Product hierarchy no. *				Part no.	SBU	Type / Description	Customer part no.
SBU	PG	PUG	Type				
02	005	016	0000001101	See list below	Power entry modules without line filter	8843-2 SP

Change of approval and rating markings on the moulding body.

Product Change Notification						8843-2 SP Change of inscription	
owner	creation date	release date	released by	change order no	rev	page	D10-042-126
sariogar	09.01.2020	18.03.2020	sariogar	2018961	A	1 of 2

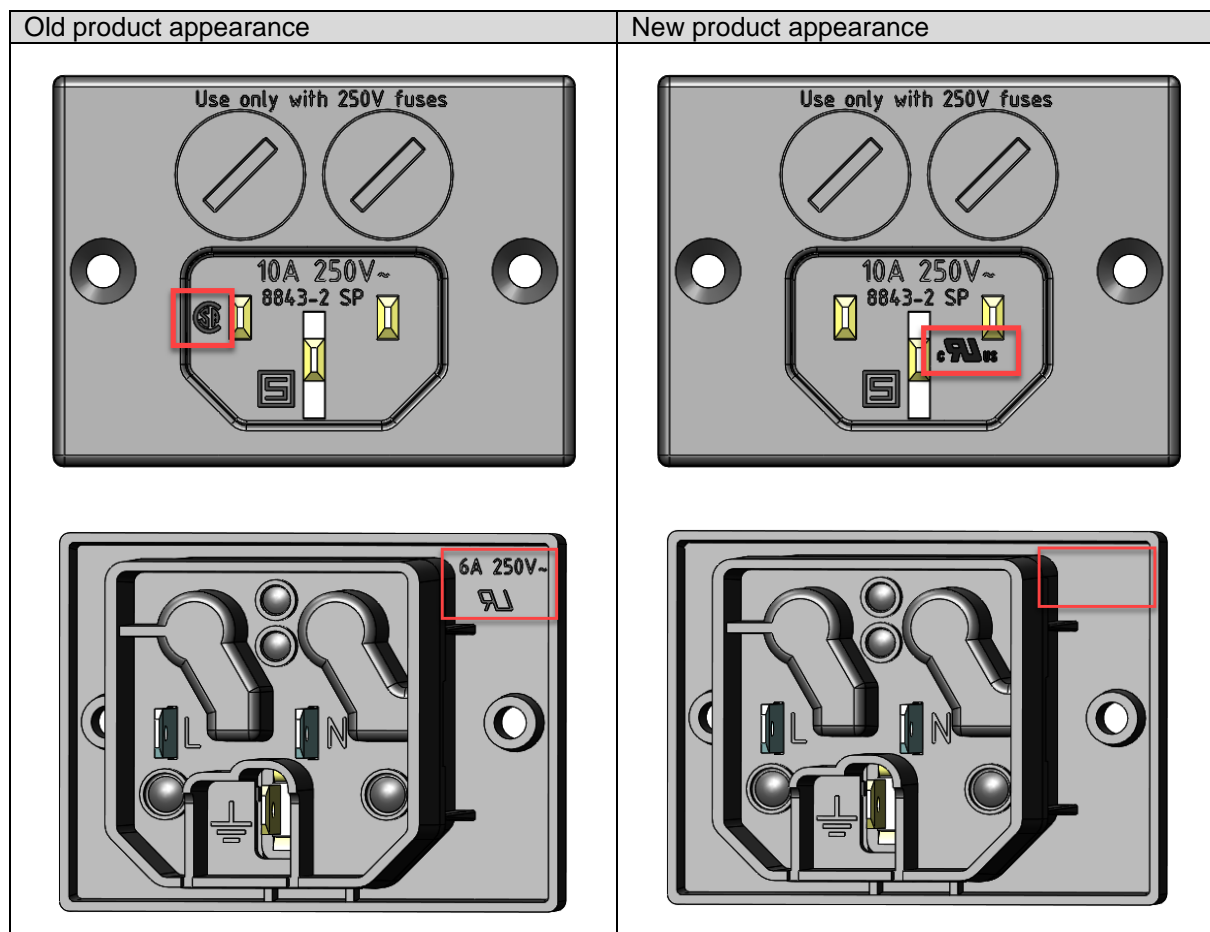
Approvals CSA and UR replaced to cURus. 6A 250V~ removed.

Standards update according to the new UL/CSA 60320-1
